**STAFF RECOMMENDATION**  
**1309 Woodland Street**  
**July 17, 2019**

**Application:** New Construction—Outbuilding/Detached Accessory Dwelling Unit  
**District:** Lockeland Springs-East End Neighborhood Conservation Zoning Overlay  
**Council District:** 06  
**Base Zoning:** R6  
**Map and Parcel Number:** 08309015600  
**Applicant:** L. Lesley Beeman, Manuel Zeitlin Architects  
**Project Lead:** Melissa Baldock, melissa.baldock@nashville.gov

<p><b>Description of Project:</b> Application is to construct a detached accessory dwelling unit.</p> <p><b>Recommendation Summary:</b> Staff recommends approval of the DADU with the following conditions:</p> <ol style="list-style-type: none"><li>1. The eave heights be no taller than ten feet (10’);</li><li>2. The footprint of the structure, as measured from exterior wall to exterior wall, be no greater than seven hundred and fifty (750 sq. ft);</li><li>3. The lap siding have a maximum reveal of five inches (5’); and</li><li>4. Staff approve all windows and doors and the roof shingle color prior to purchase and installation.</li></ol> <p>With these conditions, staff finds that the DADU meets Section II.B. of the design guidelines and 1

**DRISCOLL RES GARAGE**  
SITE PLAN - HISTORIC

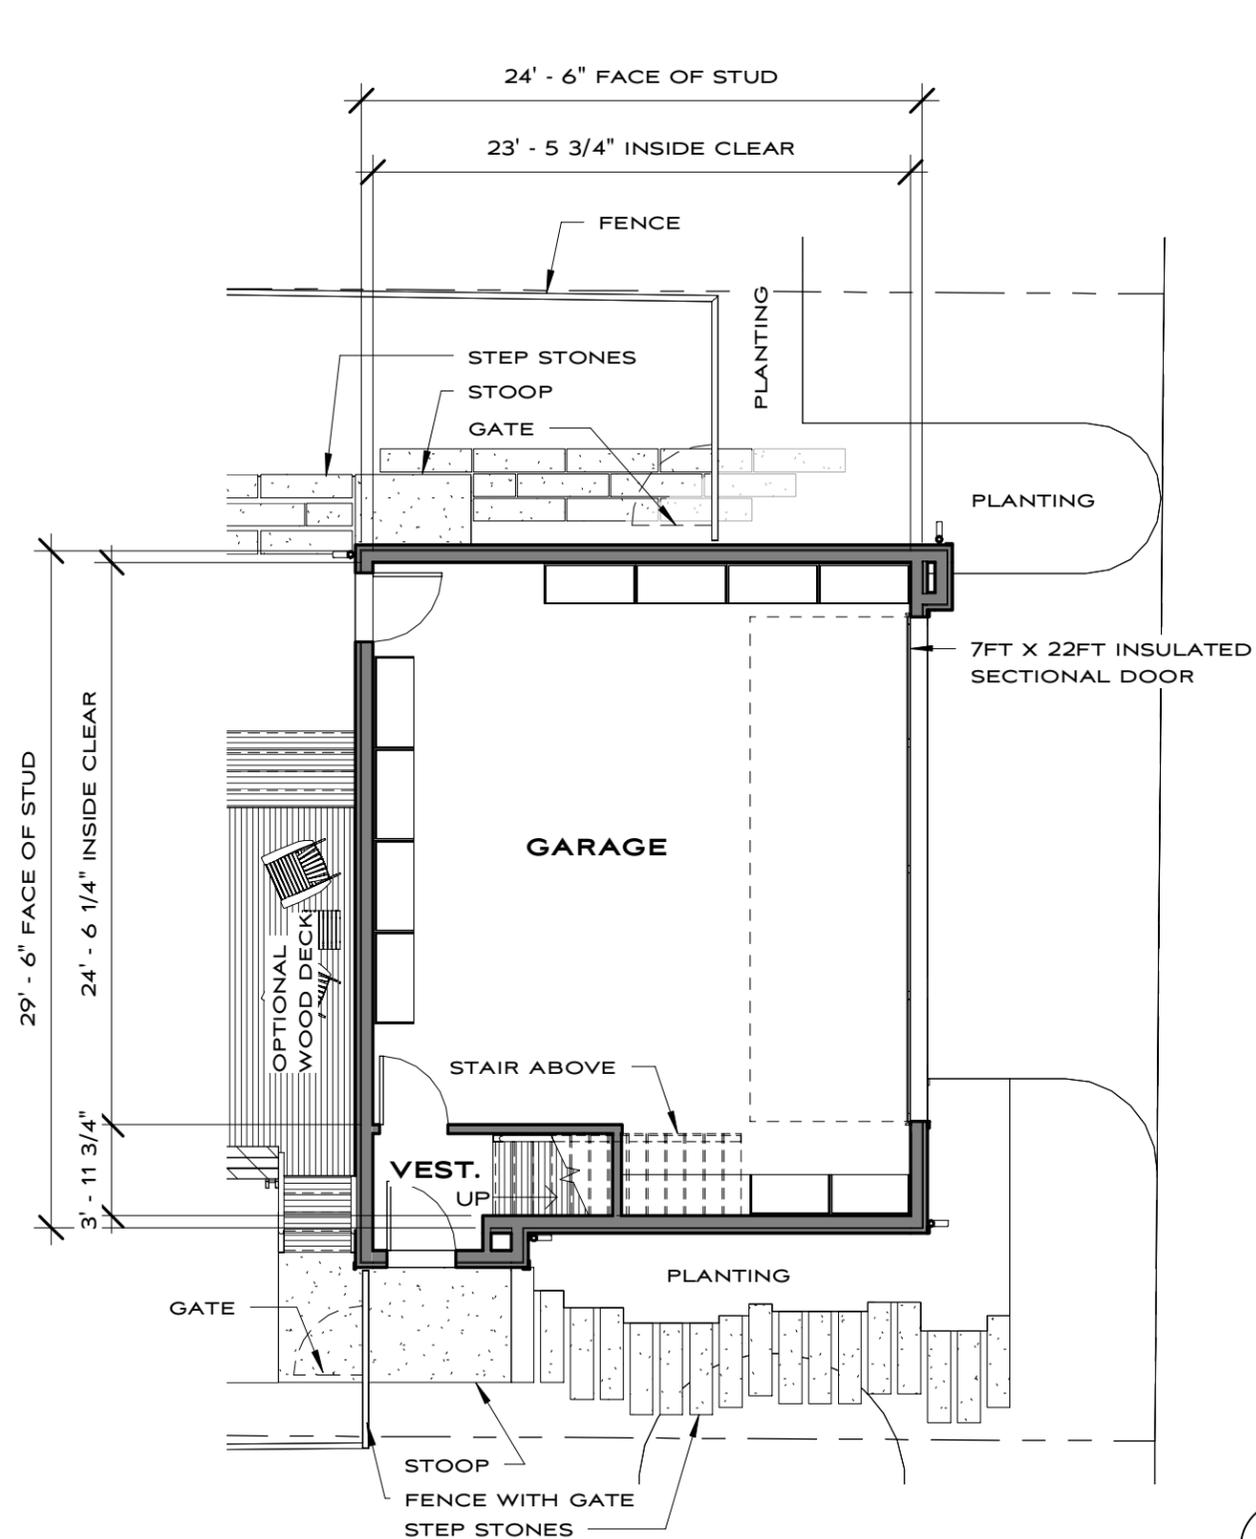
Site Planning & Setbacks: The proposed outbuilding will be larger than seven hundred square feet (700 sq. ft) in footprint. For outbuilding with a footprint of larger than seven hundred square feet (700sqft), the setback requirements are as follows:

<b>Minimum</b>	<b>Proposed DADU</b>
<b>Rear Setback</b>	5'	10'
<b>Right Side Setback</b>	5'	7'6"
<b>Left Side Setback</b>	5'	11'
<b>Distance between principal building &amp; outbuilding</b>	20'	23'

Staff finds that the DADU's location and setbacks meet the design guidelines and the DADU ordinance.

**DRISCOLL RES GARAGE**  
FLOOR PLANS - HISTORIC

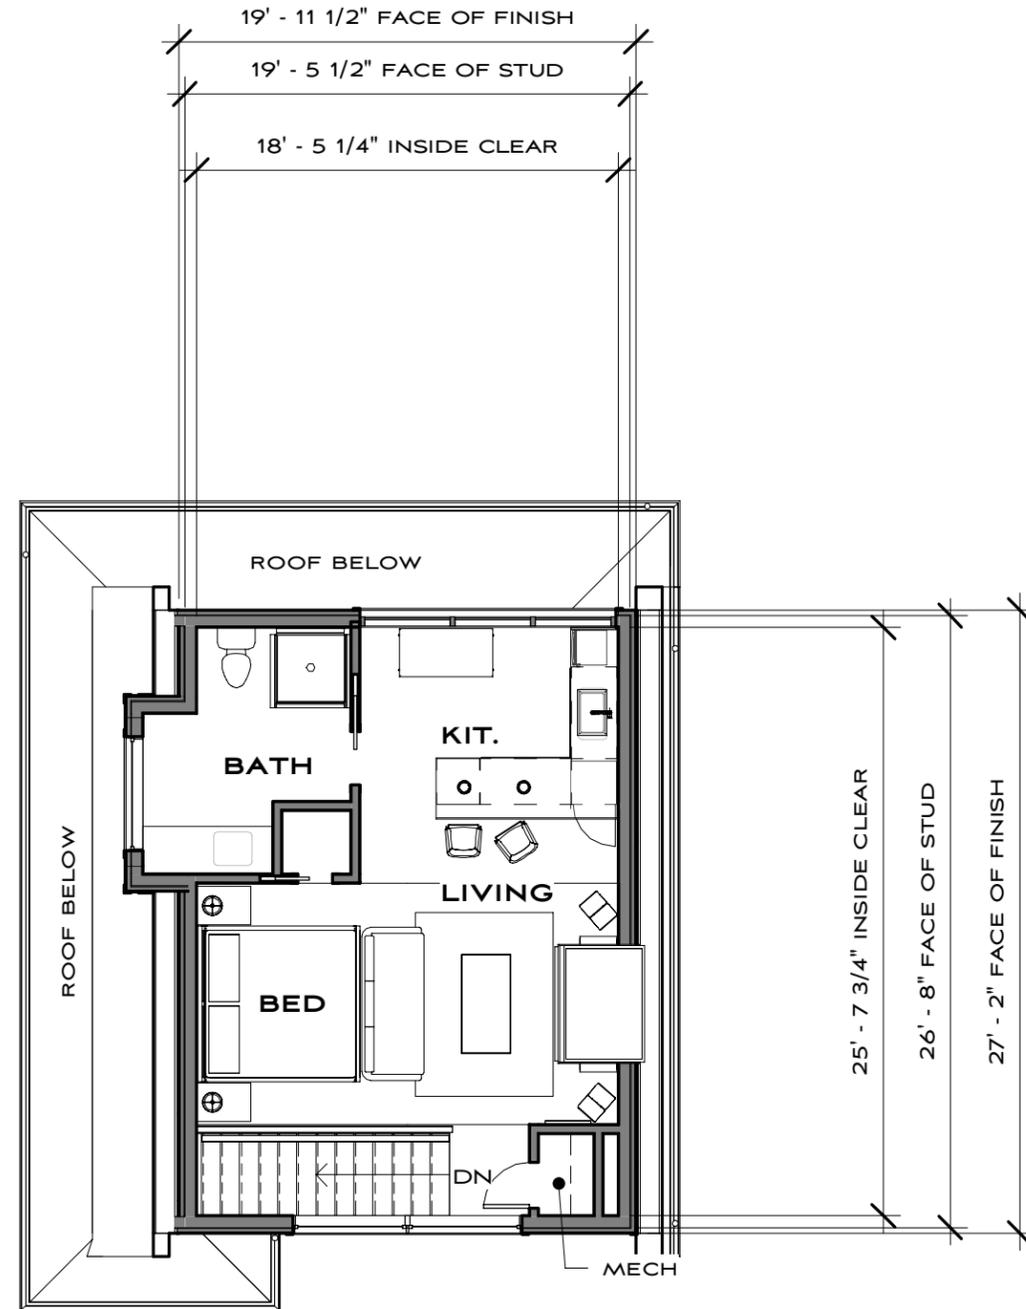
MHZA measures footprints of DADUs from exterior wall to exterior wall. In this case, the footprint of the DADU is slightly larger than the seven hundred and fifty square feet (750 sq. ft.) which is the maximum allowed under the DADU ordinance and the design guidelines.

Staff recommends that the footprint be reduced to be no larger than seven hundred and fifty square feet (750 sq. ft.) when measured from exterior wall to exterior wall.

**DRISCOLL RES GARAGE**  
 BUILDING ELEVATIONS  
 HISTORIC SUBMITTAL **H3**  
 MAY 30, 2019 1924  
 MANUEL ZEITLIN ARCHITECTS

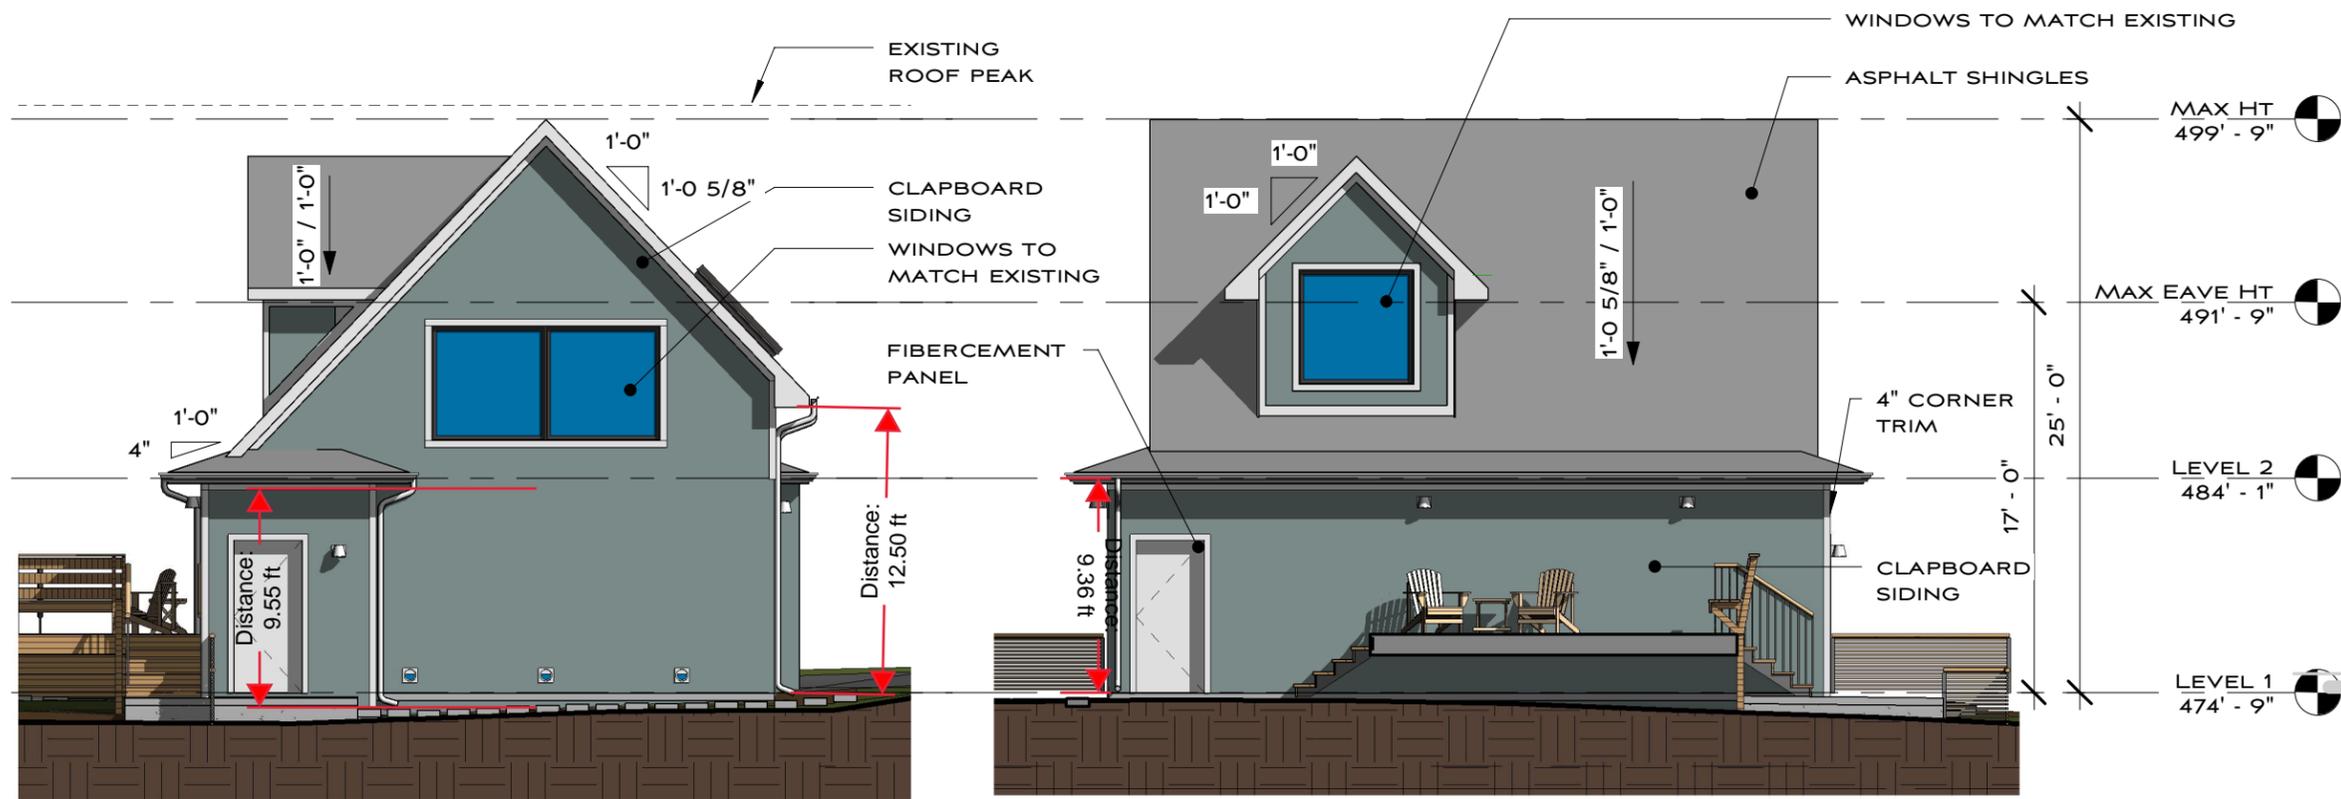
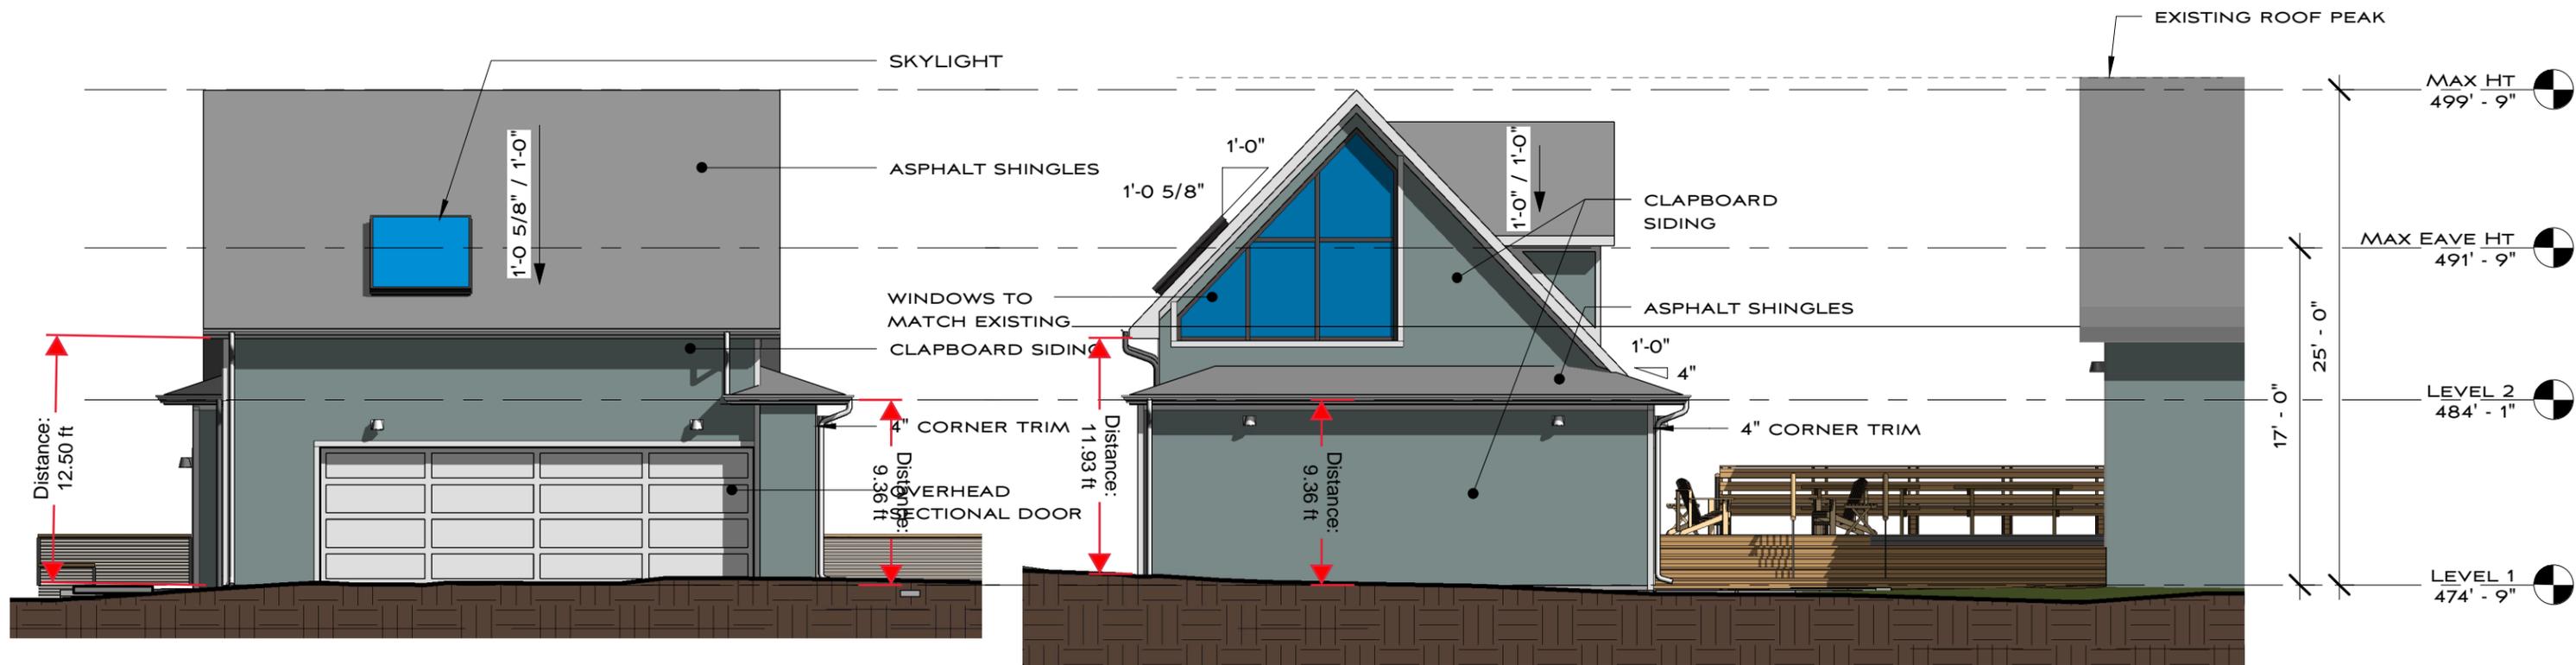
Eave Height	1 story, 10', unless existing building is less	11'-12'6"	9'-12'6"*
-------------	--	-----------	-----------

\*The DADU ordinance states, “The detached accessory dwelling shall maintain a proportional mass, size, and height to ensure it is not taller than the principal structure on the lot. The detached accessory dwelling height shall not exceed the height of the principal structure as measured to the eave line, with a maximum eave height of ten feet for single-story and seventeen feet for two-story detached accessory dwellings.” The design guidelines for all historic and neighborhood conservation overlays where DADUs are allowed under the zoning have nearly identical language in them, in italicized text.

The Commission has routinely interpreted the eave height requirements for DADUs and outbuildings as limiting the eave heights of one-and-a-half story outbuildings and DADUs to ten feet (10'). In addition, because of variations in grade, the Commission has determined that the eave and ridge height measurements of the historic house should be taken from the foundation and/or finished floor line.

In this case, the applicant is proposing a structure with eave heights along the alley that are over twelve feet (12'), which exceeds the ten foot (10') limit called out in the DADU ordinance.

Staff recommends that the eave heights be no taller than ten feet (10').
